**RE: Refined Metals Beech grove (UNCLASSIFIED)**  
Lindley, Laban C LRL to: Paul Stratman, Jonathan Adenuga  
Cc: "JEAN, RUTH (RJEAN@idem.IN.gov)", "matt.love@exide.com",  
"SGroce@idem.IN.gov"

RE: Response to EPA's Comments for CMS Report  
Refined Metals Facility  
Beech Grove, Indiana  
IND 000 718 130

RE: Response to Comments, Corrective Measures Design  
Refined Metals Corporation, Beech Grove, Indiana  
IND 000 718 130

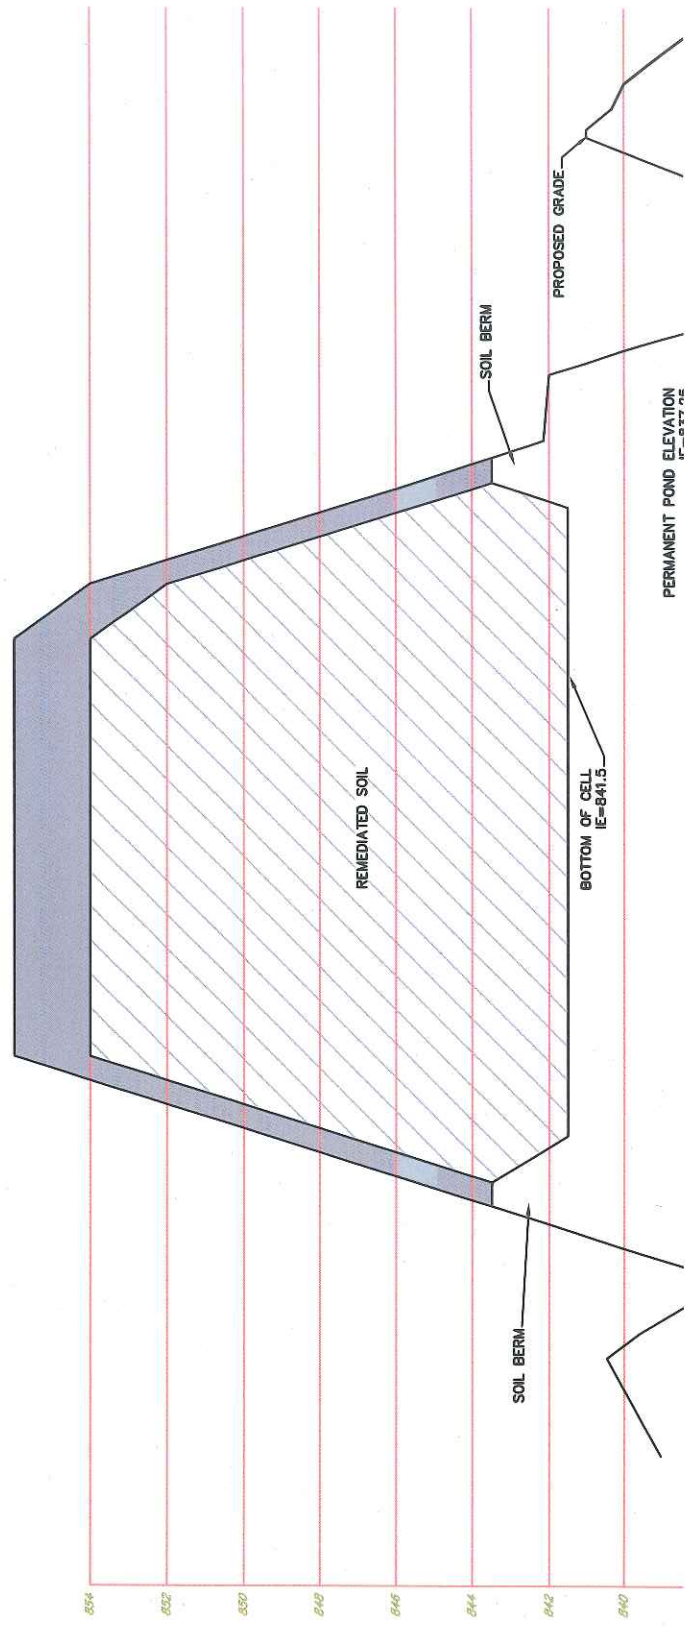
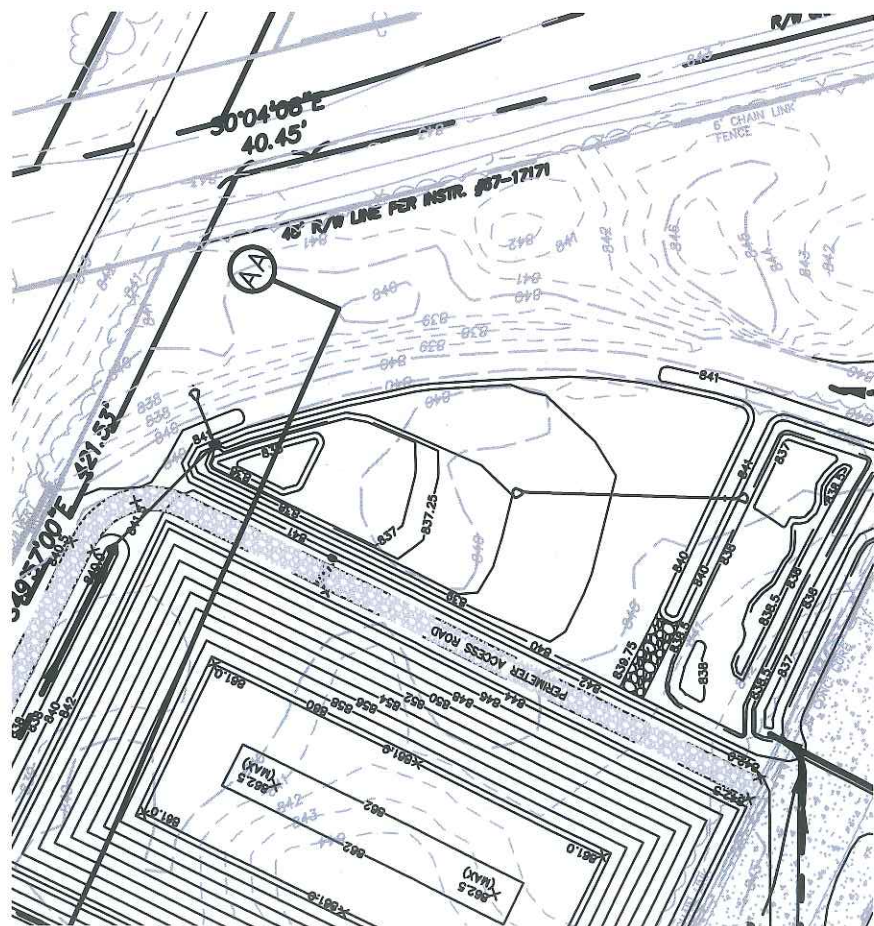
The comment relates to either increasing bottom grading in the SWM Basin to 2% to minimize the potential for standing water or installing the under-drain to facilitate drainage of the basin. Ultimately, the requirement is intended to ensure that the SWM Basin will be sufficiently dry and can be maintained. We have evaluated the feasibility of increasing the bottom slope in the SWM Basin to 2% and the alternative of providing an under-drain. Unfortunately, because of the very flat slopes at the site we do not have enough vertical relief to allow us to provide the under-drain or 2% slopes while also maintaining sufficient **storage capacity** in the SWM Basin necessary for storm water detention.

Under the Stormwater Specifications Manual, we also have the option of utilizing a wet basin. A wet basin recognizes that in some situations an SWM Basin will be difficult to drain due to very flat slope or similar constraints and instead of attempting to create a dry bottom that will be likely wet or soggy the majority of the time, it is designed to retain water on a permanent basis while providing wetland plantings to enhance water quality. Based on our design evaluation we can create a wet basin design in the vicinity of the SWM Basin outlet structure while providing a dry basin configuration between the sediment forebay and the wet basin. As shown on the attached Figure, the wet basin will have a maximum standing water surface elevation of 837.25 and water surface area of approximately 4,300 sf (0.1 acres).

Containment Cell will be 4.25 ft (841.5 – 837.25), which is the same as the separation would have been during high groundwater periods under the approved design, and greater than the vertical separation in the sediment forebay of 3.0 ft (841.5 – 838.5 (forebay overflow pipe invert)). The elevation of the 225 ft long emergency spillway will be 840.25 which means water surface elevation in the basin cannot reach 841.5. The cross-section provided on the attached Figure depicts the relationship between the proposed wet pond and the bottom of the Containment Cell.

As explained above, utilization of the wet pond area in the SWM Basin will not change the relationship between water surface elevations in the SWM Basin and the bottom of waste elevation in the Containment Cell. Through this submission we respectfully request your approval of this design modification for the proposed Corrective Measures at the Refined Metals Beech grove Site.
